South Texas Project
Units 3 and 4
Docket Nos. 52-012 and 52-013
Response to Requests for Additional Information

Attached are Nuclear Innovation North America LLC (NINA) responses to staff questions in Request for Additional Information (RAI) letter number 415 and a revised response related to Combined License Application (COLA) Part 2, Tier 2, Section 9.1, "Fuel Storage and Handling." The attachments to this letter include non-proprietary responses (Attachments 1, 2 and 3) and proprietary responses (Attachments 5, 6 and 7) to the following RAIs:

RAI 09.01.02-9

RAI 09.01.02-17**QUESTION:**

Figure 17: Baseline Corrected Displacement Seismic Time History

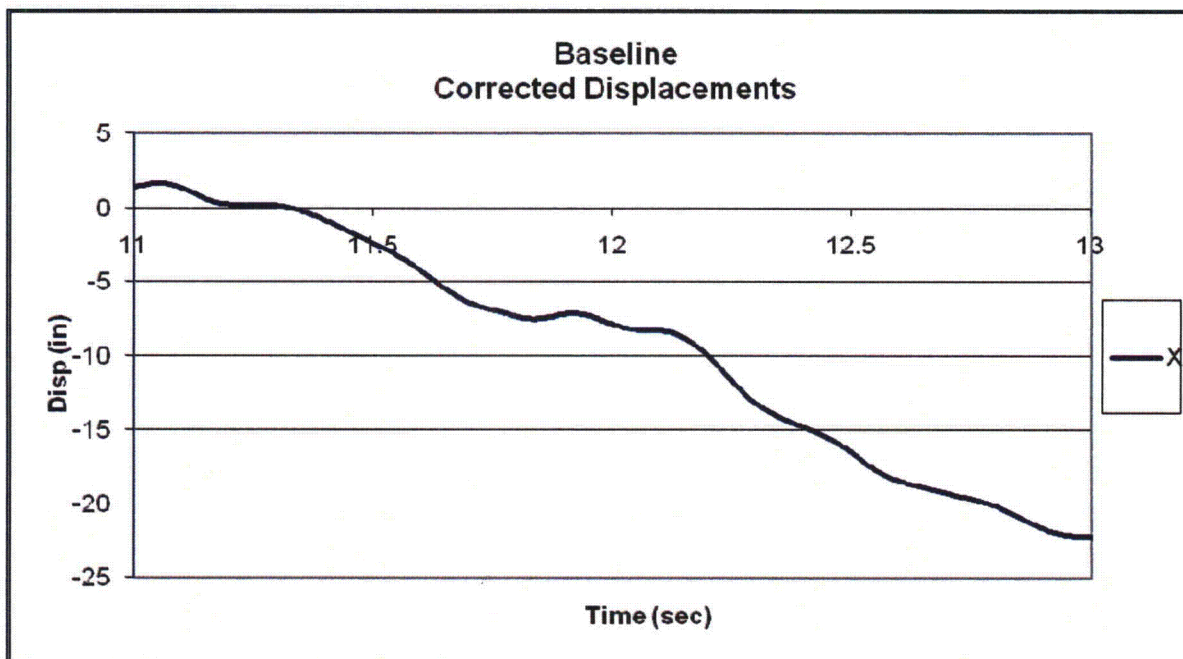
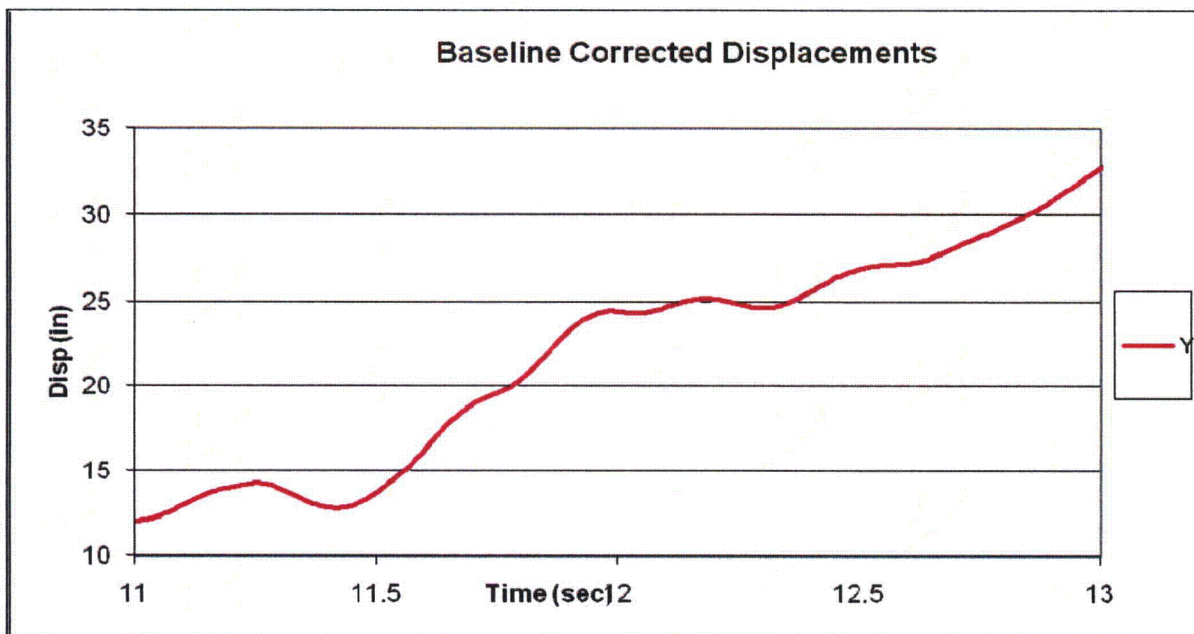
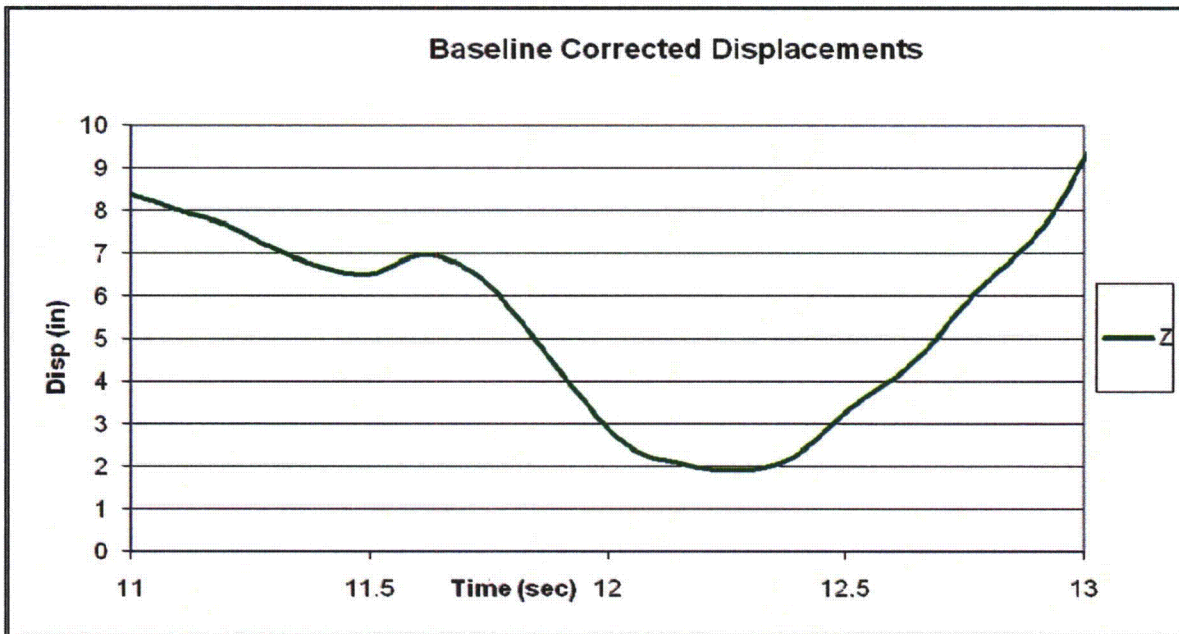
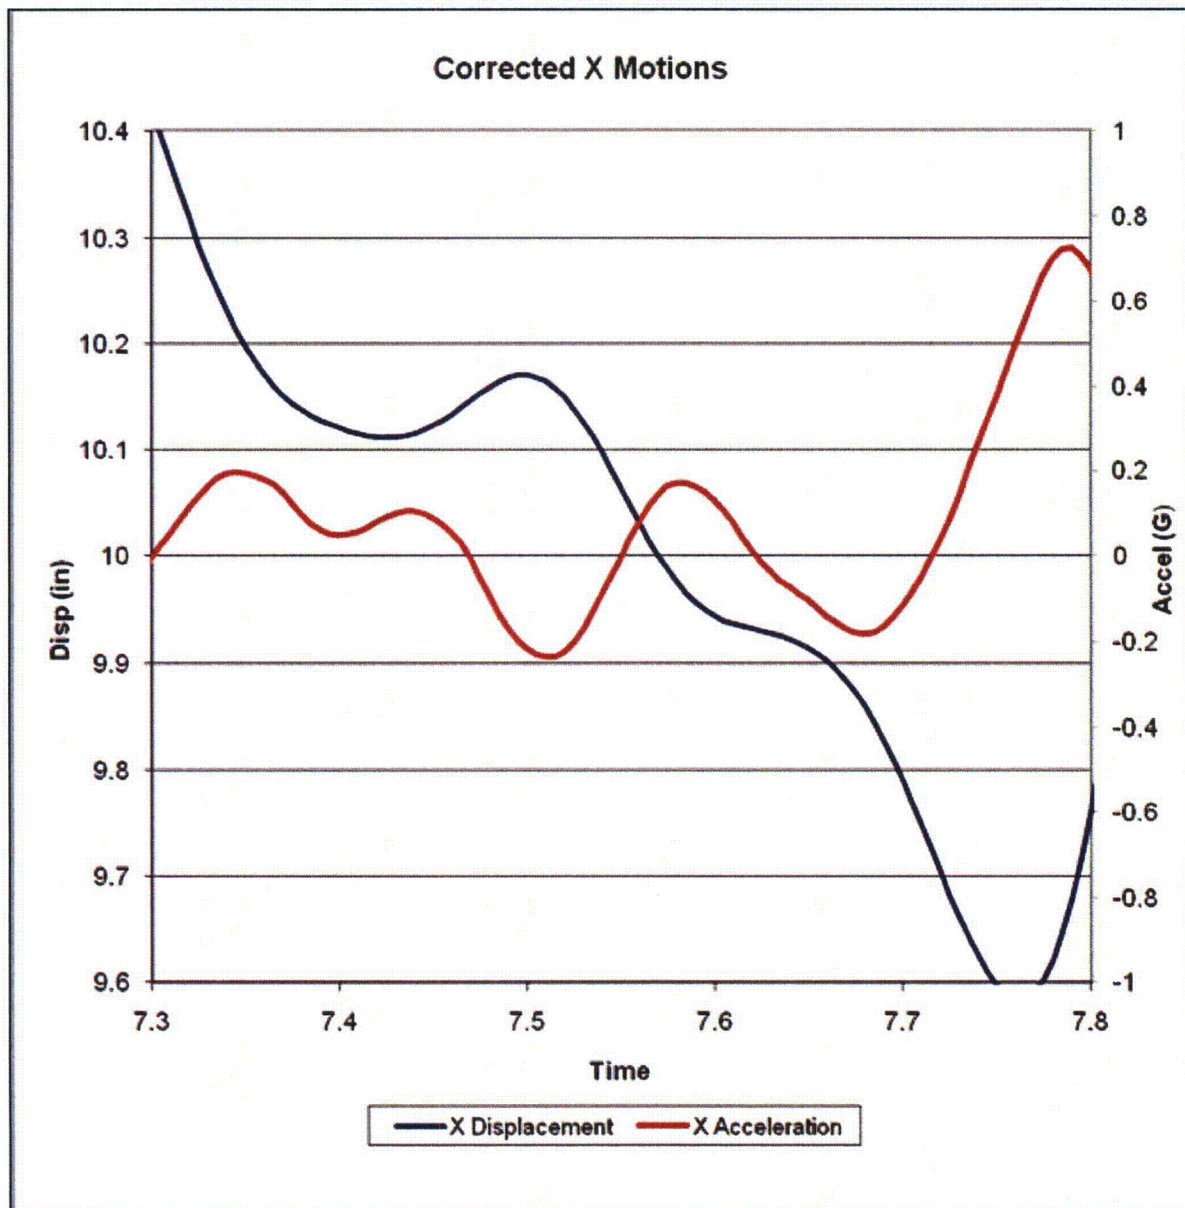
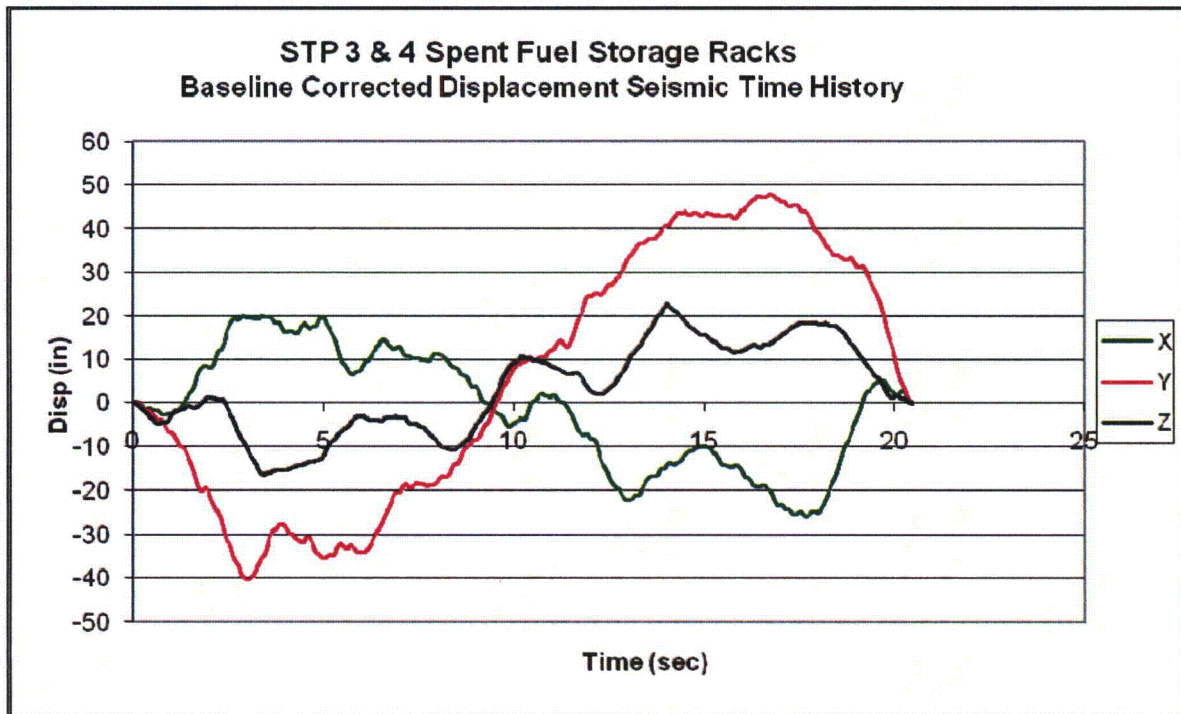
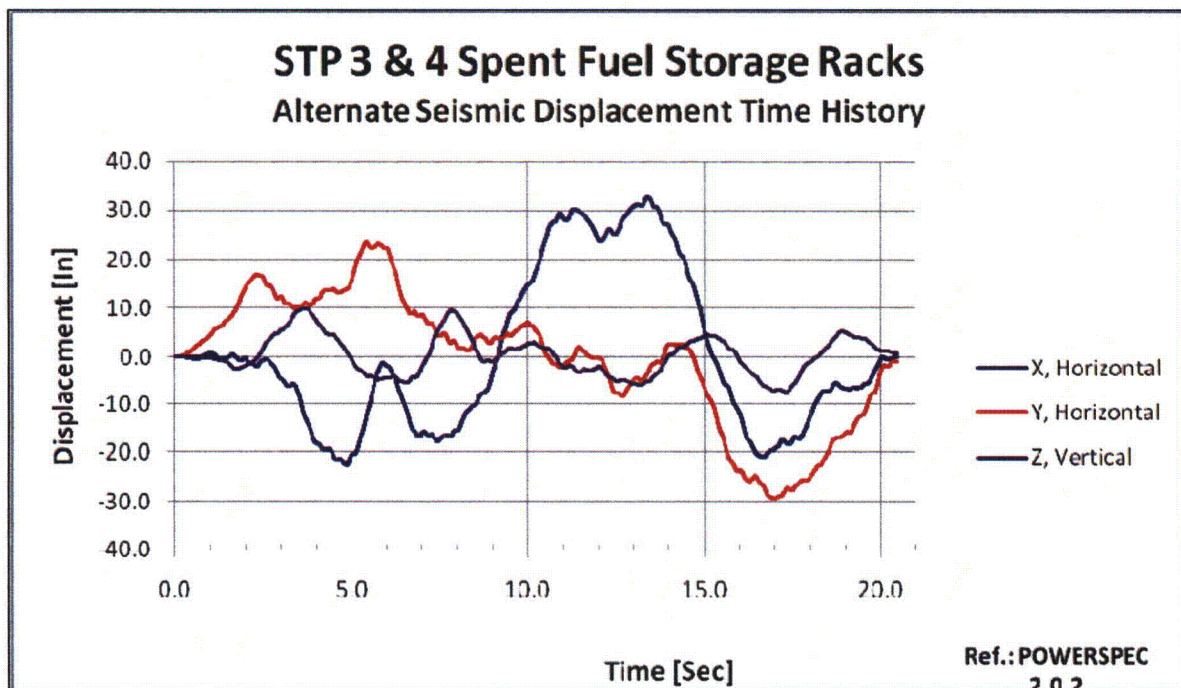
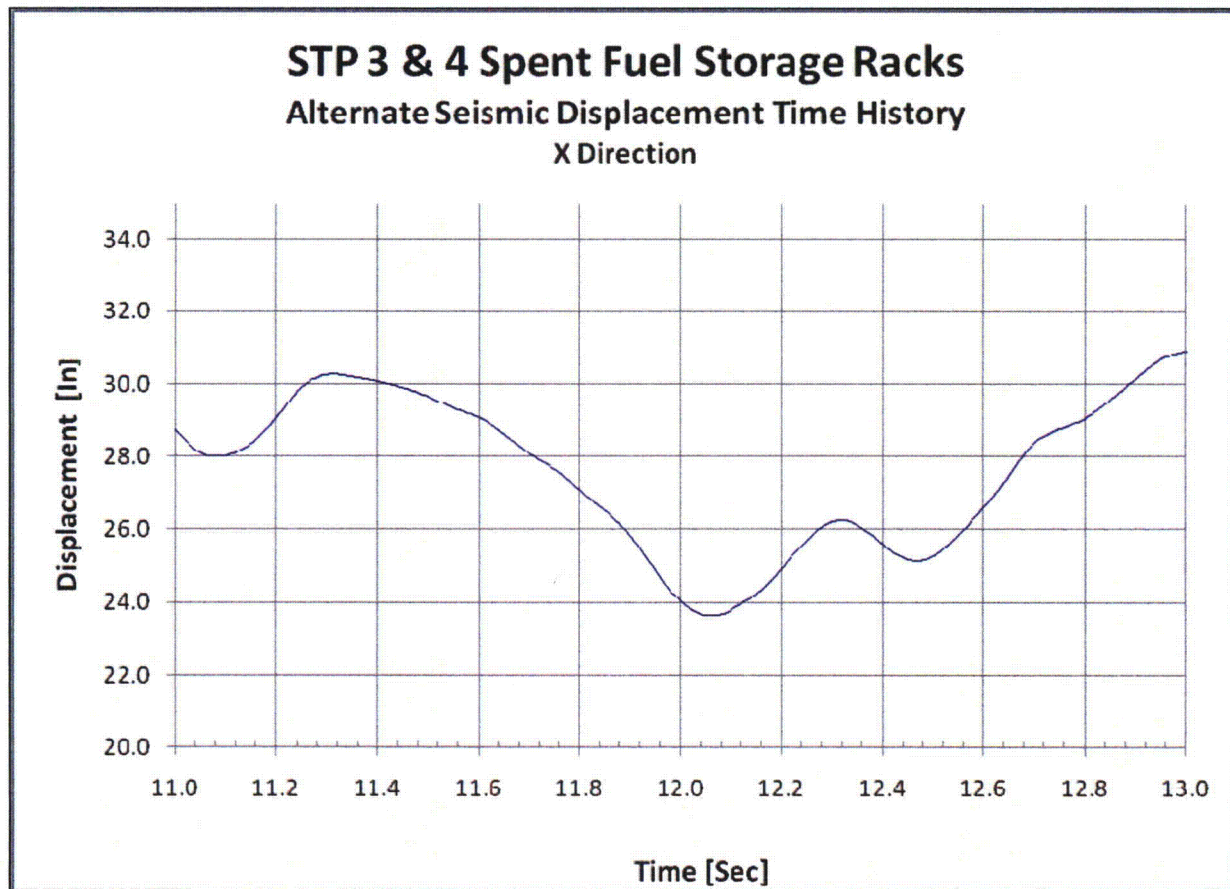
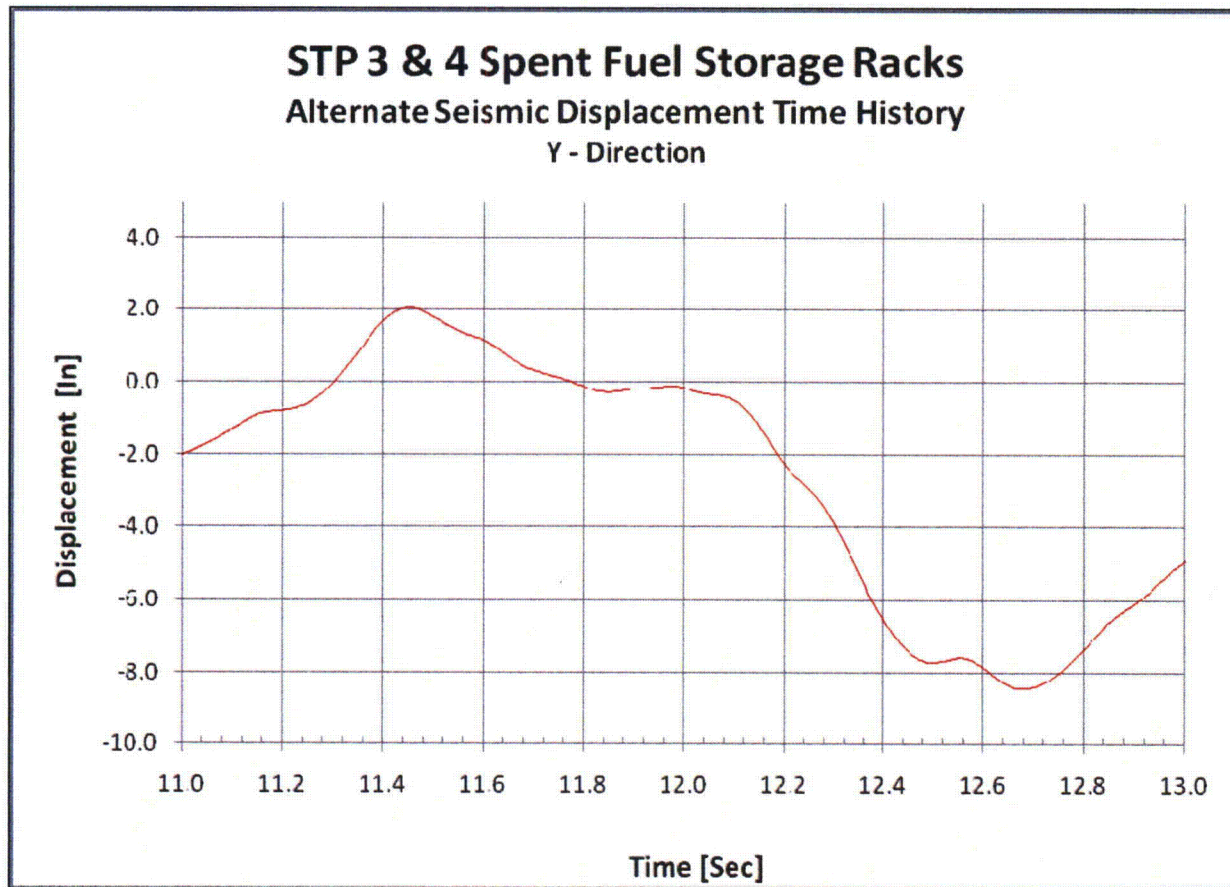
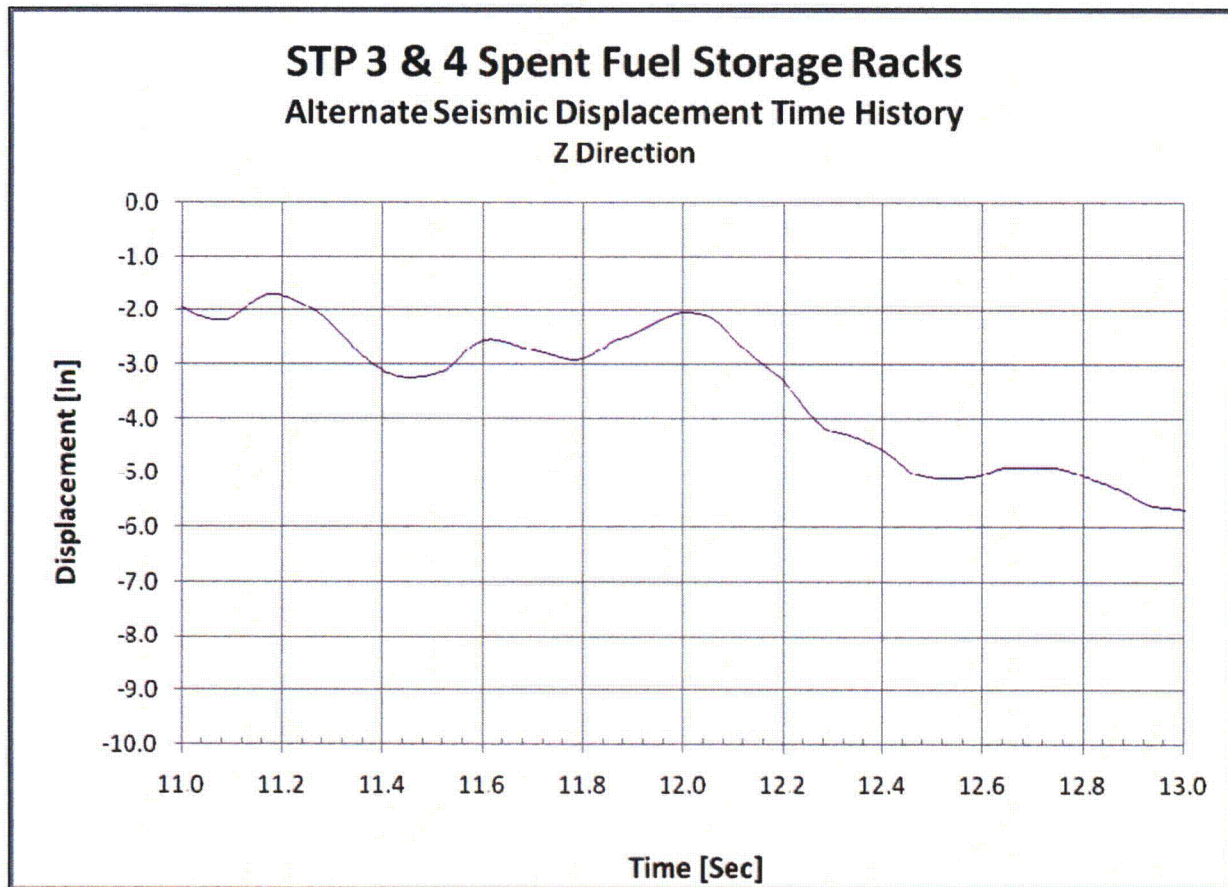
- f. The plots of the baseline corrected displacement time histories (x, y, z) presented in Figure 4-5 of the Technical Report exhibit several characteristics that require clarification and explanation: (1) All 3 displacement time histories exhibit a dominant sinusoidal response with a period which is same as the duration of the acceleration time history (2) All 3 displacements are zero at three specific time steps. (3) Although there is only 1 horizontal target spectrum, the peak x displacement is approximately $\frac{1}{2}$ of the peak y displacement. (4) The 2 horizontal displacement histories are completely out-of-phase with each other; the vertical displacement history is perfectly in-phase with y and completely out-of-phase with x. Describe how the displacement time histories are developed from the synthetic acceleration time histories, and provide the technical basis for the adequacy of the generated displacement time histories.

The displacements are the double integration of baseline corrected acceleration time histories that satisfy statistical independence criteria. All fuel rack results reported are relative to the floor motion. Figures 13, 14, and 15 show the baseline corrected displacement time histories on a magnified time scale. These figures show that the high frequency displacements in each direction are not in phase and are not a constant ratio of each other. Figure 16 shows a portion of the X motion for the corrected acceleration time history and the corrected displacement time history, which is calculated by double integrating the corrected acceleration time history. The fuel racks dynamically respond to the higher frequency, smaller amplitude cyclic waves shown in these plots. Figure 17 shows Technical Report Figure 4-5 with the data point markers removed.

The comparison between the baseline corrected and alternate displacement time histories (double integration of the synthesized acceleration time histories using the second method described in the response to RAI 09.01.02-9(d)) is shown in Figures 17 and 18, respectively. Figures 17 and 18 both show low frequency, large amplitude displacements containing superimposed high frequency, low amplitude displacements. The fuel racks dynamically respond to the higher frequency smaller amplitude cyclic waves shown in both figures. Figures 19, 20, and 21 show the alternate displacement time history on a magnified time scale for each of the applied directions. Figures 19, 20, and 21 reflect high frequency, low amplitude characteristics that are similar to Figures 13, 14, and 15.

The baseline corrected time histories shown in Technical Report Figure 4-5 are developed from three statistically independent synthesized acceleration time histories satisfying all the criteria of SRP 3.7.1. Validation that these time histories are adequate for the fuel rack seismic analysis is demonstrated by comparison with displacement time histories derived from synthesized acceleration time histories using an independent method. Both sets of displacement time histories yielded similar seismic response results when applied to the fuel rack. Therefore, both time histories are equally valid for the fuel rack seismic analysis and it is not necessary to replace the existing time history input.

Figure 4-1 Seismic Input and ANSYS® FEM Coordinate Directions

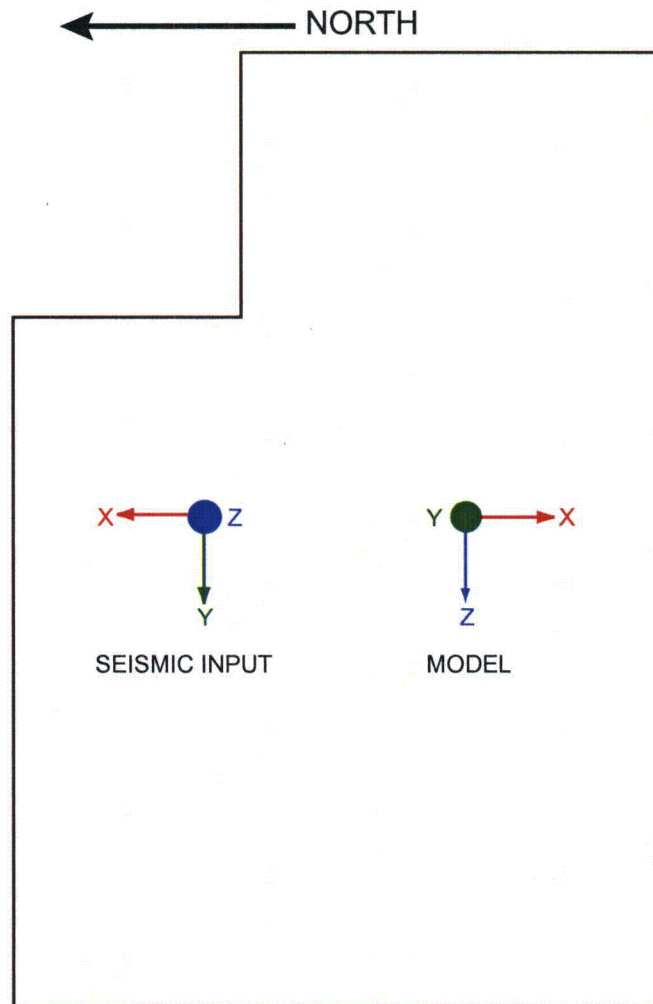
3. Figure 4-1 appears to be a plan view. If this is a plan view, then Y is vertical and Z is horizontal west. This is inconsistent with the text in Section 4.1, which defines Y as horizontal west and Z as vertical. Correct the text and figures to be consistent. Also confirm that the seismic input was properly applied in the 3 coordinate directions.

3. There were two coordinate systems used in the analysis of the Spent Fuel Storage Racks. The seismic inputs coordinate system is as described in the first paragraph of Section 4.1 "Time History Inputs," and is consistent with the time history plots presented in Figures 4-2, 4-3, 4-4, and 4-5. This differs from the coordinate system used by ANSYS[®] software for the FEM modeling as graphically portrayed on several of the ANSYS[®] figures. Figure 4-1 will be revised as shown below to clearly indicate the differences between the two systems.
